**DALLAS FORT WORTH  
INTERNATIONAL AIRPORT**

**ADDENDUM NO. 2**

**Northeast End Around Taxiway Package I  
East Air Freight Taxiway and Utilities**

**CONTRACT NO. 9500623**

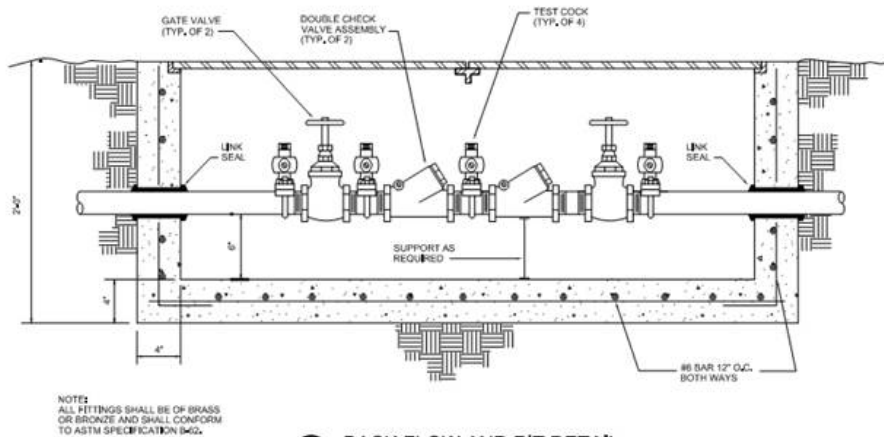
Question: There is a Bedding and Excavation Dimensions Table on plan sheet CG503 for the RCP but there is none for the 2'x4' Reinforced Concrete Box Culvert (Class III). Please add this information for the Reinforced CBC.

(A) Refer to revised Plan Sheet CG-503.

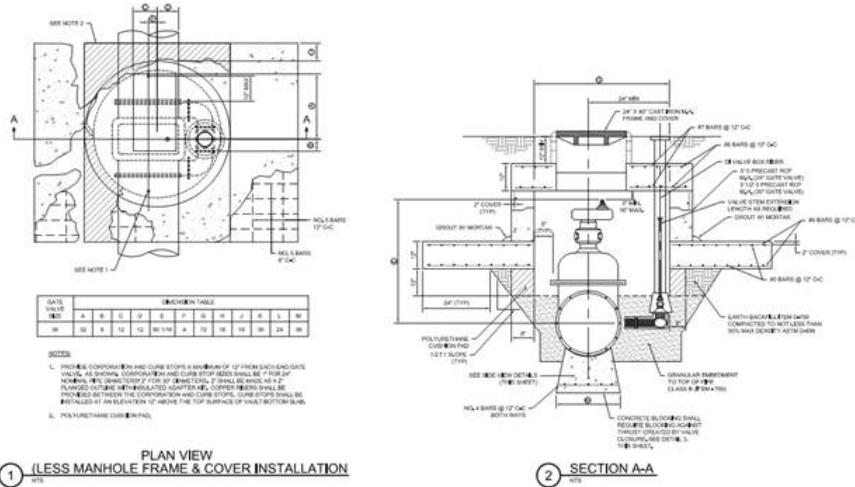
Question: Bid quantity is 1 each. Plan sheet CU-502 shows Backflow and Pit Detail

What constitutes the "8" PVC Check Valve"? Is it intended to be this entire detail? Please provide more detail for the pit, frame and grate, supports, etc.

(A) Refer to revised Item 33 12 16, and revised Plan Sheet CU-502.
